Product Change Notice (PCN)

PCN Number: PCN-0451112R-01

Product(s) Affected: *PJ-017DH*

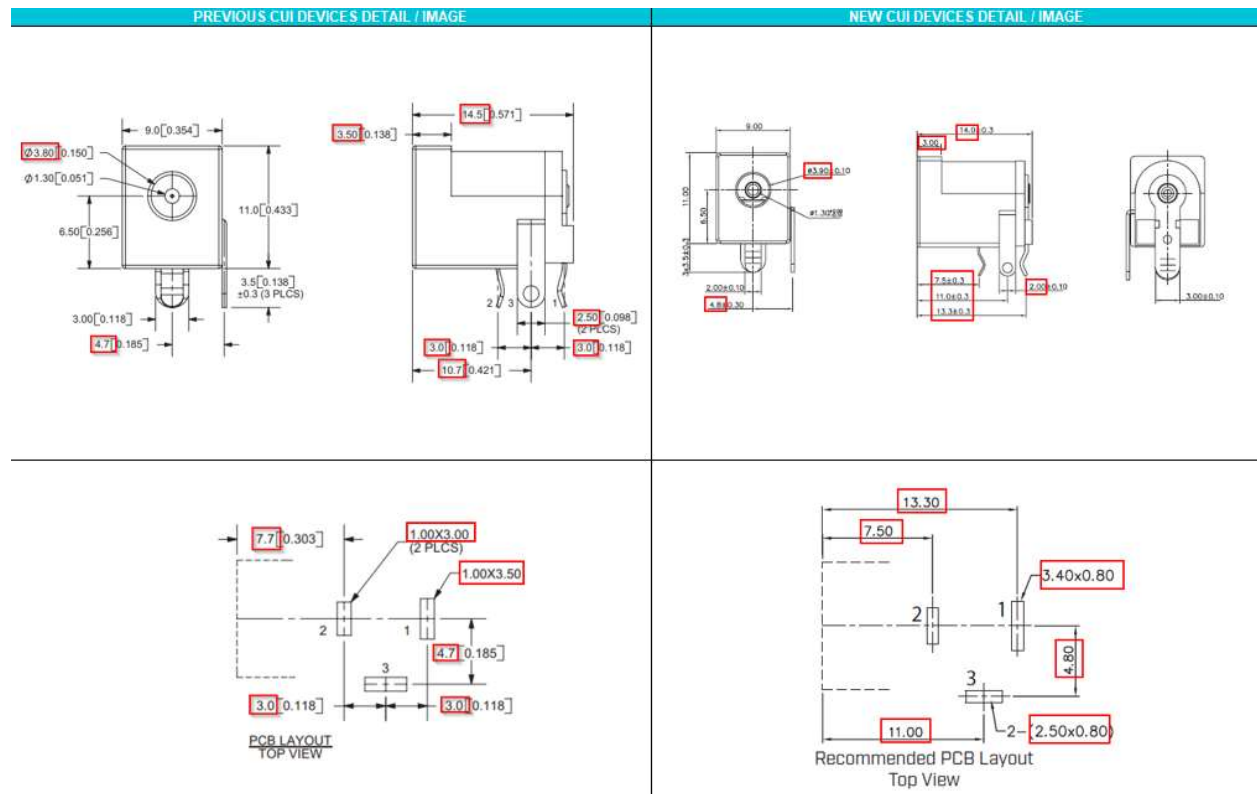
Description of Change: *Minor Housing and footprint differences. Material Change on the housing and terminals. See image Below*

PREVIOUS CUI DEVICES DETAIL / IMAGE			NEW CUI DEVICES DETAIL / IMAGE		
	MATERIAL	PLATING	DESCRIPTION	MATERIAL	PLATING/COLOR
center pin	copper	nickel	center pin	brass	nickel
terminal 1	brass	silver	terminal 1	brass t=0.40	silver
terminal 2	copper alloy	silver	terminal 2	bronze t=0.30	silver
terminal 3	brass	silver	terminal 3	brass t=0.40	silver
plastic	PBT		cover	PA9T [UL94V-0]	black
			housing	PA9T [UL94V-0]	black

MATING PLUG
Jack Insertion Depth: 9.15 mm

MATING PLUG
Jack Insertion Depth: 8.7 mm
